Project Name	Ickleford Mill, Ickleford
Subject	Off-Site Highways Works Note
Reference	25232
Date	February 2026

ROAD SAFETY AUDIT REPORT

Project: Ickleford Mill, Arlesey Road, Ickleford, Hertfordshire
Proposed Highway Works

Project Name	Ickleford Mill, Ickleford
Subject	Designer's Response to Stage 1 Road Safety Audit
Reference	25232/N03
Date	February 2026

Scale:
1:250 @ A1
1:500 @A3

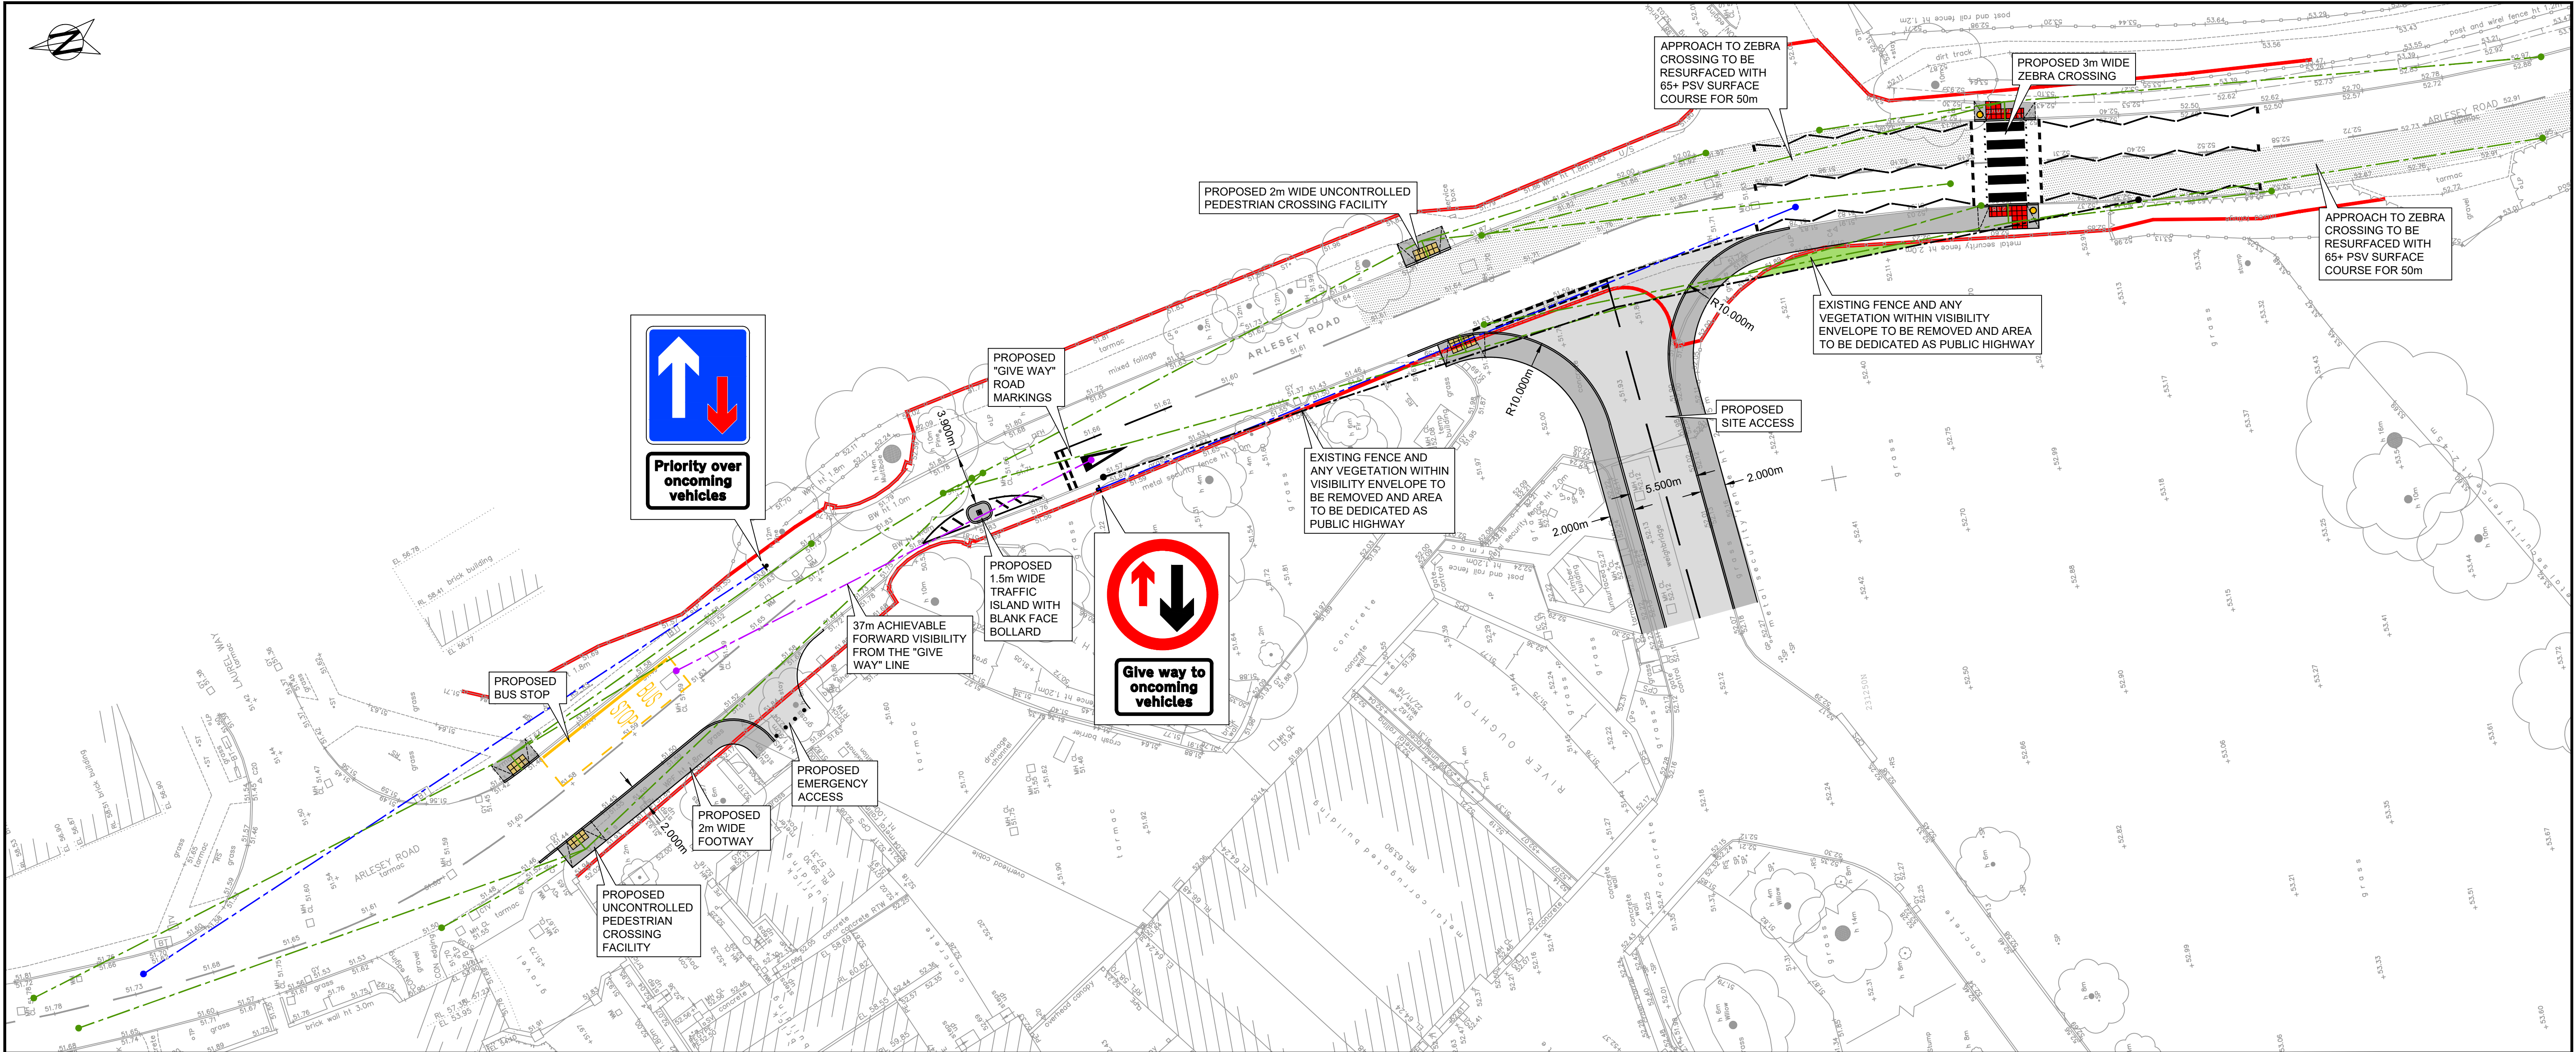
- 1.2.3 This note will be submitted in conjunction with a Section 73 application, which is being submitted alongside the reserved matters application.
- 1.2.4 It is noted that the consented scheme did not provide any details for how pedestrians might access the emergency access. No restrictions to prevent access were put forward and crossing facilities would likely be required as part of further detailed design stages.

- 1.2.5 It is also noted that no Stage 1 Road Safety Audit supported the proposals at the outline stage.
- 1.2.6 The principle of the changes to the access have been discussed with the highway authority. No in-principle objections were raised but a request for a Stage 1 Road Safety Audit to support the proposals was made.

- 1.3.2 The site layout requires the relocation of the emergency access approximately 15 metres to the south of the position shown in the approved drawing. This is required in order to effectively use the site and provide homes within an appropriate street scene.
